Job No. 10641

11th March 2011

**RE: PART 3A APPLICATION FOR CONCEPT PLAN APPROVAL
MIXED-USE DEVELOPMENT – 566-594 PRINCES HIGHWAY, KIRRAWEE
RESPONSE TO SUTHERLAND SHIRE COUNCIL SUBMISSION - STORMWATER**

PIT 3

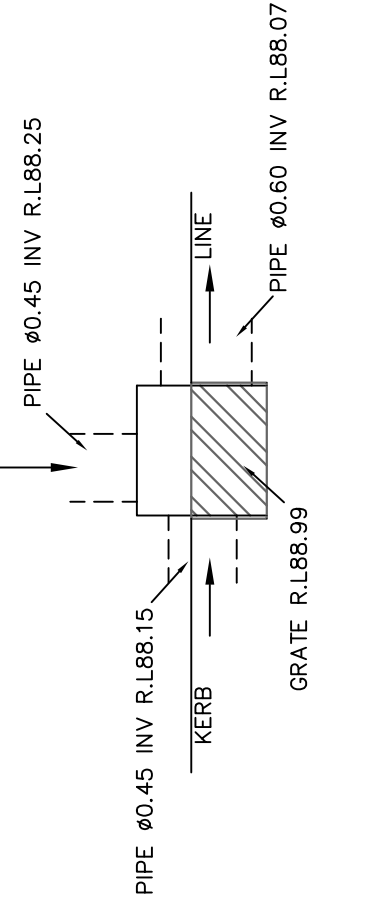
Appendix	Title	Comment
Appendix A	Sutherland Shire Council - Detail Survey Plan Oak Road, Kirrawee - Brick Pits and Quarry	- Detail Survey Plan indicates point of “Stormwater Interception and Disposal” – bottom right hand corner of site
Appendix B	Extract from Sydney Water Report, April1993 Kirrawee Brick Pit: Environmental Status and Suitability for Landfill	- Section 2.2.2 states “Escape of water from the site occurs:.....(b) via a stormwater outlet in the south eastern corner”
Appendix C	Norton Survey Partners – Survey Plan and Pit Details	- Sheet 1 and 2 shows Pit 3 (located at the upstream end of Flora Street) with 450mm-diameter pipe connecting from upstream.
